# Response to Submissions for the **Dargues Gold Mine**

## Modification 3

MP10\_0054

**November 2015**

**Figure 1** presents the amended Project Site layout incorporating all components or activities to be retained should the Proposed Modification, as amended, be approved.

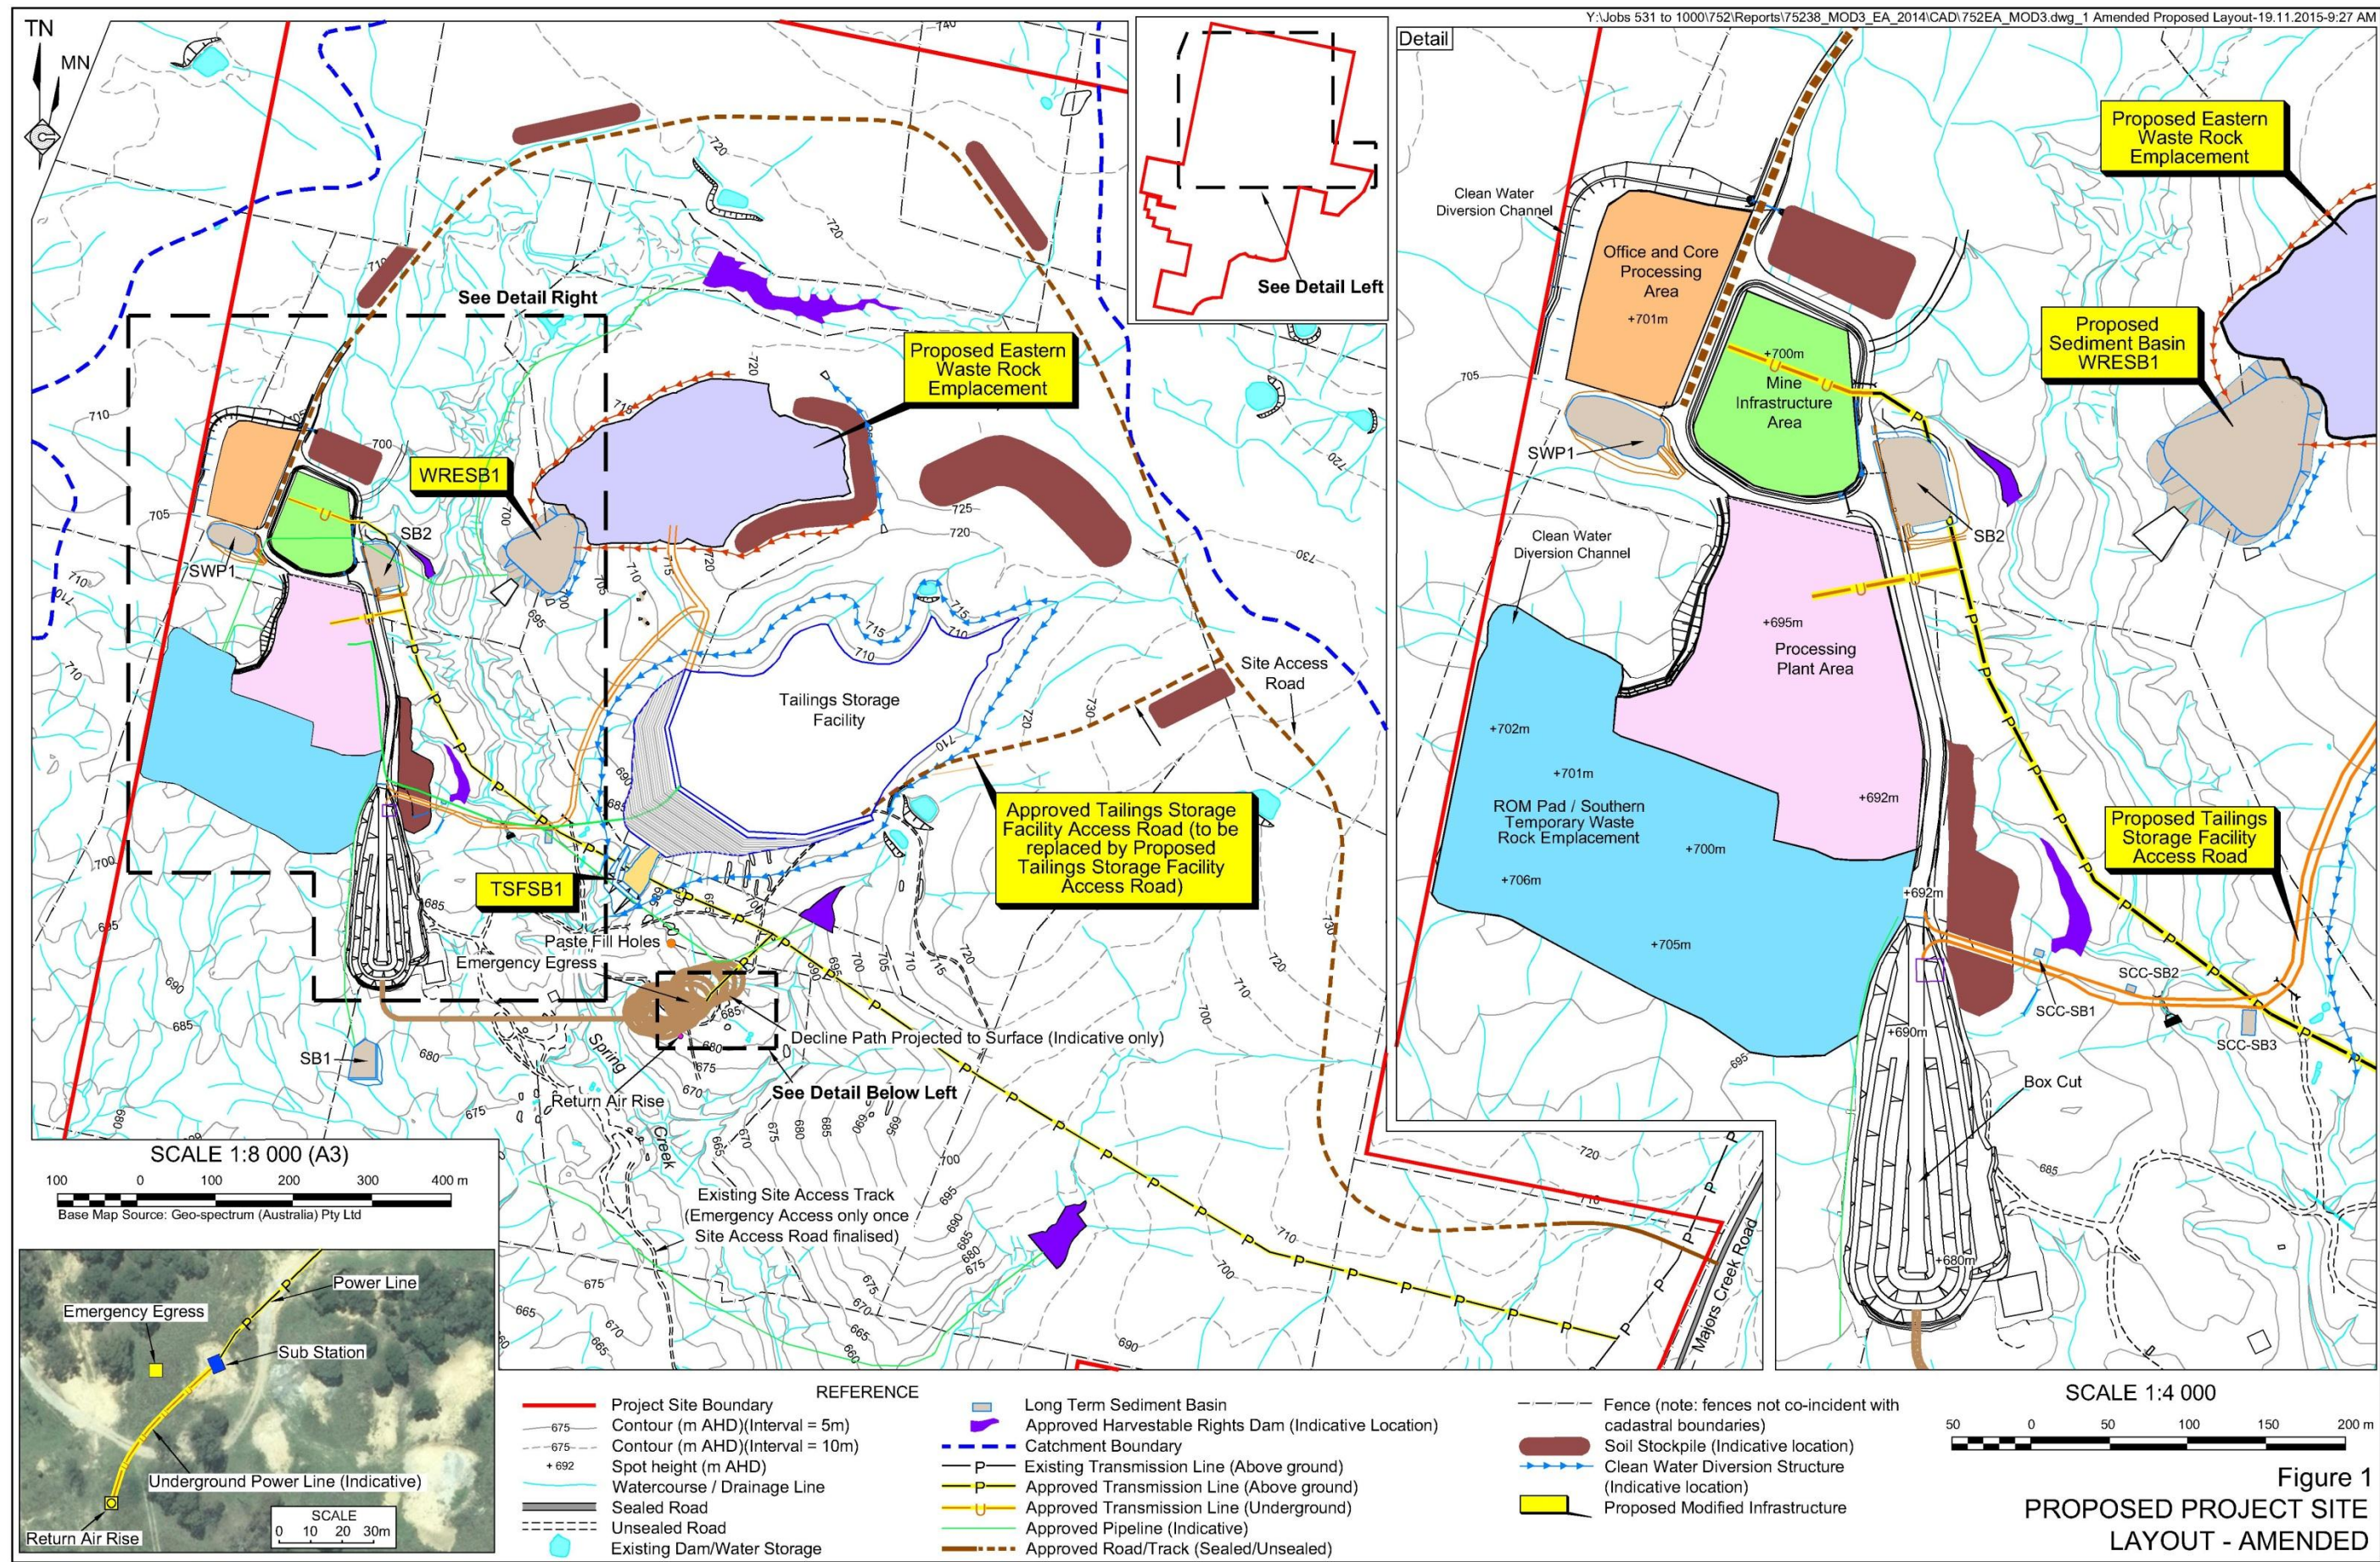
Following completion of the exhibition period, the Proponent undertook a review of the submissions received. The Proponent also consulted with a range of stakeholders, including the Department of Planning and Environment and Environment Protection Authority. As a result of that review and consultation, the following proposed activities have been withdrawn from the Proposed Modification.

- Final processing of gold concentrate on site to produce gold doré or unrefined gold bars using a conventional carbon-in-leach (CIL) processing plant, including:
  - transportation, storage, use and disposal of cyanide within the Project Site; and
  - placement of leached concentrate tailings within the Tailings Storage Facility.
- Construction of an enlarged Tailings Storage Facility.

As a result of the withdrawal of the above components from the Proposed Modification, the following approved activities that were proposed to be removed from the Project would be retained as described in the following documents.

- Construction and use of the approved processing plant, including the crushing, grinding, gravity and flotation circuits and gold room (Section 2.6.2 to 2.6.4 of RWC (2010a)).
- Construction and use of the approved concentrate loading facility (Section 2.6.5 of RWC (2010a)).
- Construction and use of the approved Tailings Storage Facility (Section 2.7 of RWC (2010a)).
- Transportation of the concentrate from the Project Site to the Kings Highway using semi-trailers (Section 2.9.3 of RWC (2010a)).
